STAFF REPORT

HEARING DATE: April 13, 2021

SUBJECT: H-2020-0047
Prescott Ridge – AZ, PP, PS, ~~ALT~~

A. Master Plan Conceptual Rendering & Medical Campus Conceptual Development Plan - REVISED

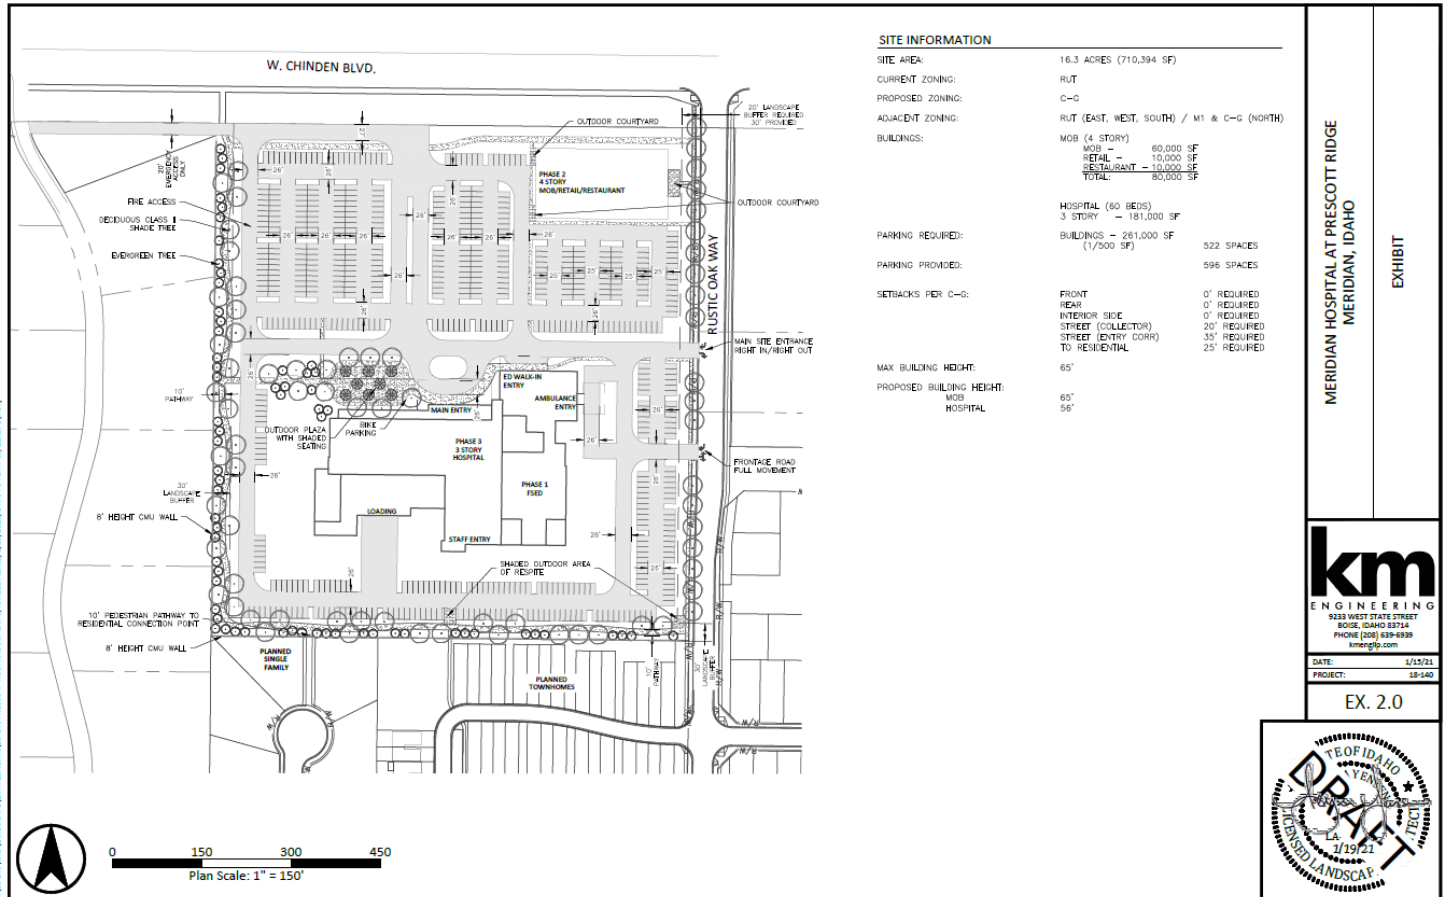
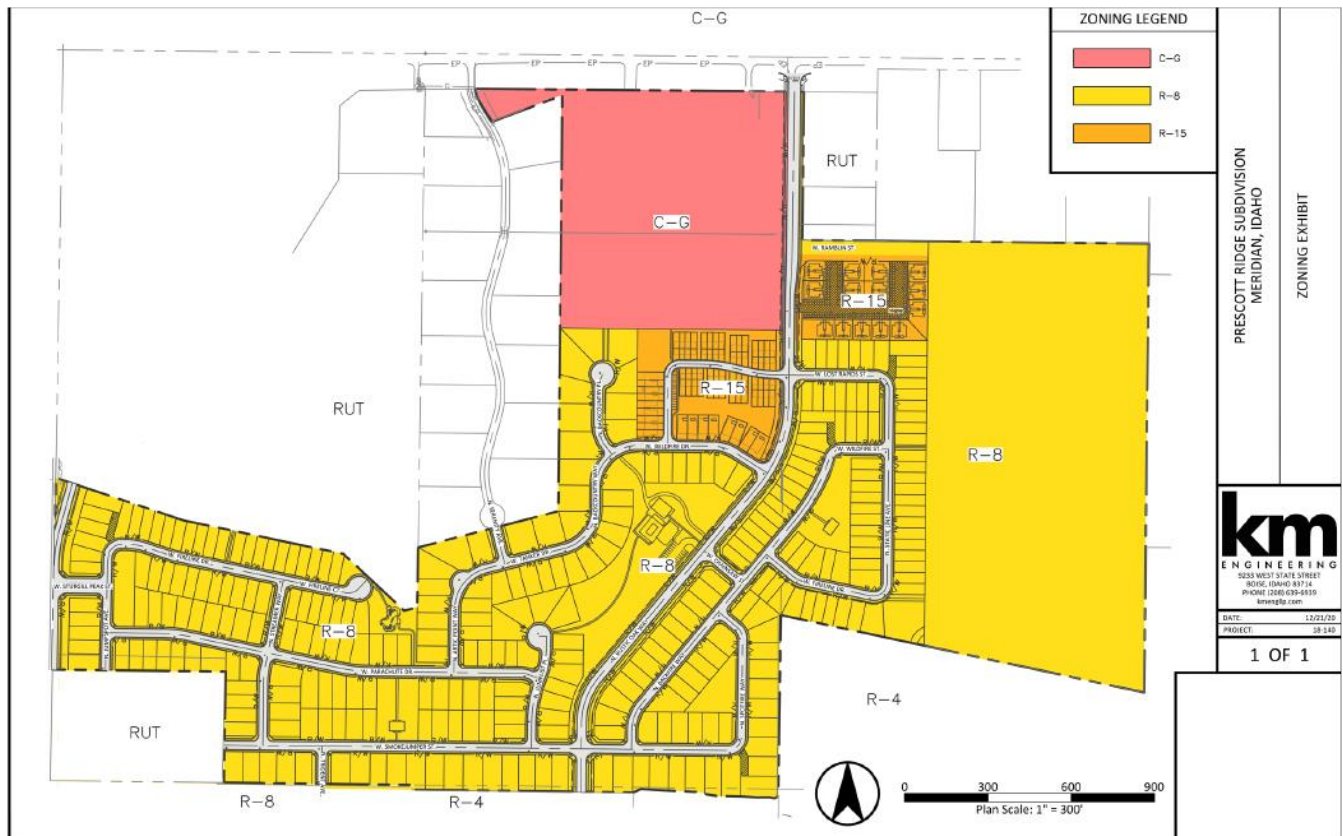
- “In developments where multiple commercial and/or office buildings are proposed, the buildings should be arranged to create some form of common, usable area, such as a plaza or green space.”
The Master Plan depicts ~~an outdoor yard area at the south end of the hospital~~ a shaded sitting area three (3) outdoor courtyard areas in front of around the medical office building, a large outdoor plaza/green space area in front of the hospital with a shaded seating area, and a pedestrian pathway within a 30’ wide landscaped common area along the southern and western boundaries of the commercial portion of the development abutting residential uses with two (2) shaded areas of respite. Staff recommends the concept plan is revised prior to the City Council hearing to reflect common usable area such as a plaza or green space more central to the development with buildings arranged around the common area in accord with this provision.

- “The site plan should depict a transitional use and/or landscaped buffering between commercial and existing low- or medium-density residential development.”
*There are existing low density homes on 1-acre lots along the west boundary of this site in Peregrine Heights Subdivision adjacent to the area proposed to be zoned C-G and developed with a medical campus. A 30’ wide densely landscaped buffer is proposed along the west and south boundaries of the C-G zoned property adjacent to existing and proposed abutting residential uses along with an 8’ tall CMU wall as a buffer to future commercial uses. **Parking is proposed along these boundaries except for a 4-story medical office building proposed at the southeast corner of the commercial development, which Staff recommends is shifted to the north to front on the main entry drive aisle off W. Rustic Oak Way as a better transition to the residences to the south.***

- b. Relocate the parking on the east side of the medical office building to the west side of the building and shift the building further to the east away from the adjacent residential properties (see revised concept plans in Section VIII.A);

5. A frontage road parallel to W. Chinden Blvd./SH 20-26 shall be constructed as depicted on the conceptual development plan in Section VIII.A in accord with UDC 11-3H-4B.3e.

7. The entire first floor of the medical office building shall consist of retail and restaurant uses as proposed to provide a mix of uses as desired in the Mixed-Use designated area in accord with the Comprehensive Plan.
8. The final design of the site shall be consistent with the general Mixed Use and Mixed Use – Regional guidelines in the Comprehensive Plan (see pgs. 3-13 thru 3-15 and 3-18 thru 3-19).
9. The buffer along the west boundary of the site shall incorporate a 2-foot tall berm with an 8-foot tall wall on top of the berm to assist in blocking the noise from the commercial development if approved by the Peregrine Heights Homeowner's Association (HOA). If not approved by the HOA, the landscaping and wall shall be installed as depicted on the conceptual development plan.

C. Preliminary Plat (date: ~~8/28/2020~~ 10/21/20 ~~11/20/20~~ 12/22/20), Phasing Plan & Lot Layout Exhibit REVISED

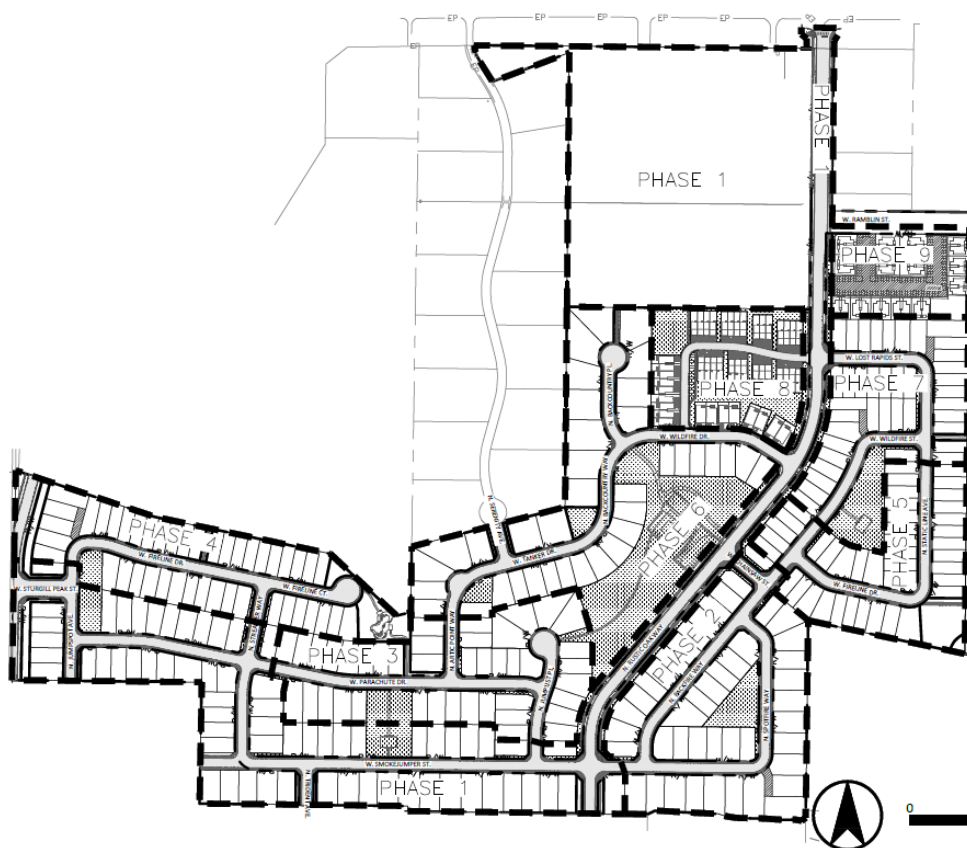
- d. Reduce the number of lots along the southern boundary to provide better transition to the R-4 properties planned to the south in The Oaks subdivision (lots were reduced by 5 along the south and southeast boundaries, see revised plat in Section VIII.C).

- g. Lots 70-83, Block 12 in the multi-family portion of the development shall be revised to depict parking and access driveways on a common lot with an ingress-egress/parking easement for each buildable lot. ~~A revised plat shall be submitted at least 10 days prior to the City Council hearing depicting this change.~~ Done

- h. Extend W. Smokejumper St. as a stub street to the out-parcel (Parcel #S0428233620) at the southwest corner of the site.
3. The landscape plan submitted with the final plat application shall be revised as follows:

D. Landscape Plan (date: 8/26/2020 10/9/2020 11/19/20 12/22/20) – REVISED

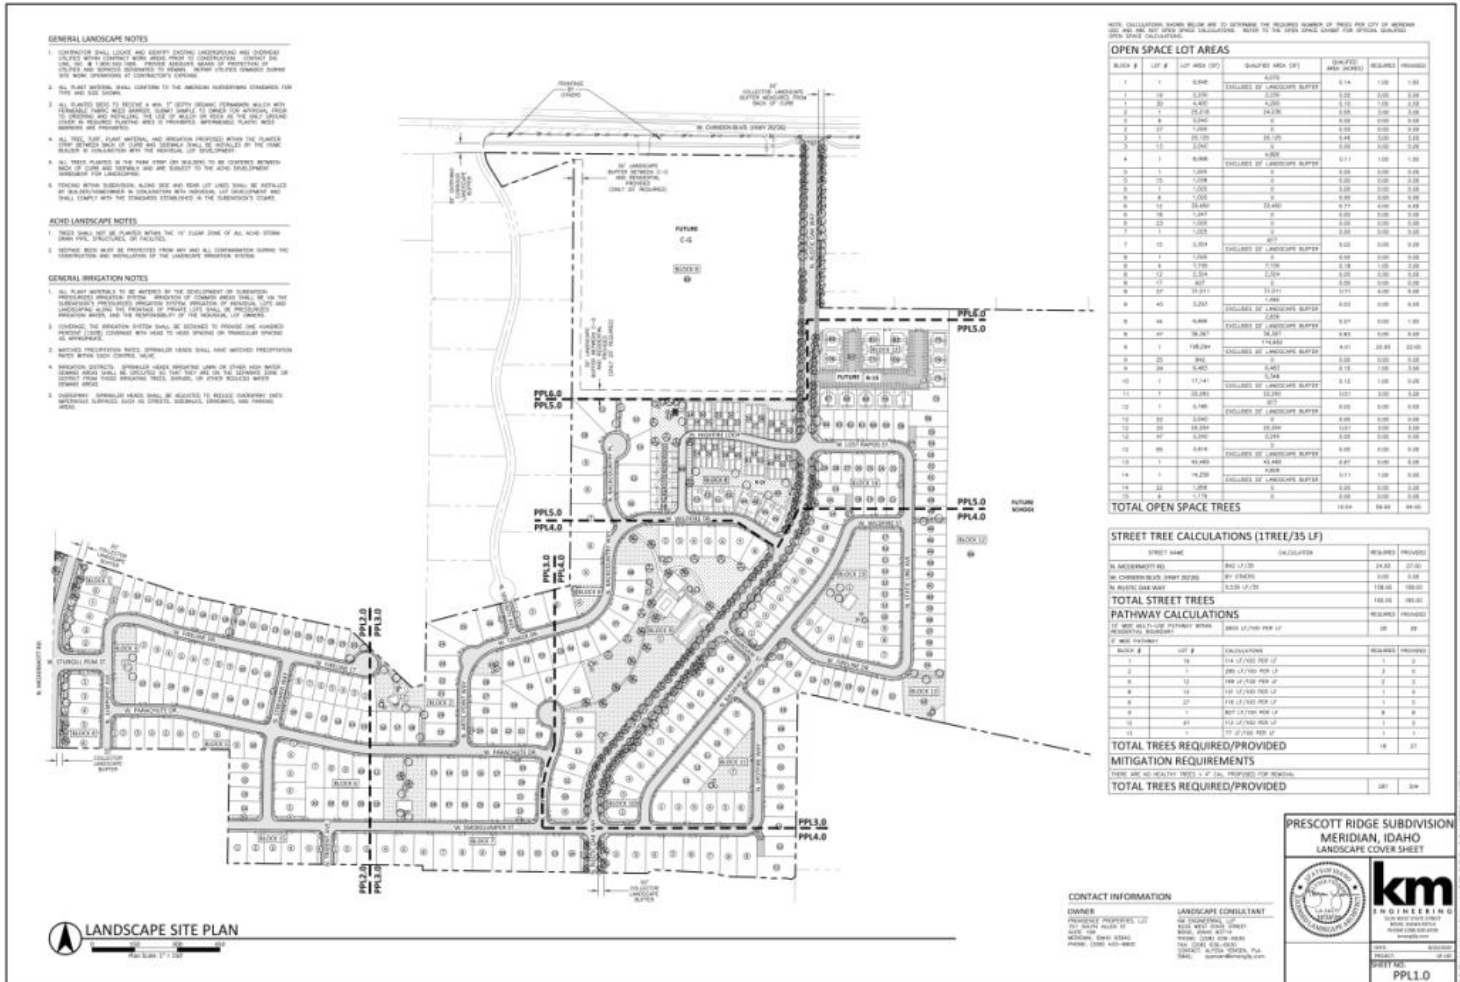
- a. Depict a detail/cross-section of the berm or berm and wall combination required as noise abatement within the street buffer along W. Chinden Blvd./SH 20-26 and N. McDermott Rd.; also address how the wall will be constructed to avoid a monotonous wall, that demonstrates compliance with the standards listed in UDC 11-3H-4D.

- ~~b. Remove Lot 1, Block 15 as it's ACHD right of way and cannot be platted as a common lot.~~
 - c. Depict a detached sidewalk/pathway (as applicable) along all collector streets (i.e. N. McDermott Rd., N. Rustic Oak Way and W. Ramblin St.) and W. Chinden Blvd./SH 20-26 in accord with UDC 11-3A-17. *A detached 10-foot wide multi-use pathway is required within the street buffers along N. McDermott Rd., W. Chinden Blvd./SH 20-26, the east side of N. Rustic Oak Way and W. Ramblin St.*

- d. Landscaping shall be depicted on either side of all pathways as set forth in UDC 11-3B-12C.
 - e. If existing trees are proposed to be removed from the site, the Applicant shall coordinate with Matt Perkins, the City Arborist, to determine mitigation requirements per the standards listed in UDC 11-3B-10C.5. Mitigation information shall be included on the plan. If existing trees are proposed to be retained on site, they shall be depicted on the plan.

- g. Revise the fencing type around the perimeter of Lot 1, Block 2 and Lot 37, Block 12 to comply with the standards listed in UDC 11-3A-7A.7 to provide more visibility of the common areas in accord with CPTED design strategies.
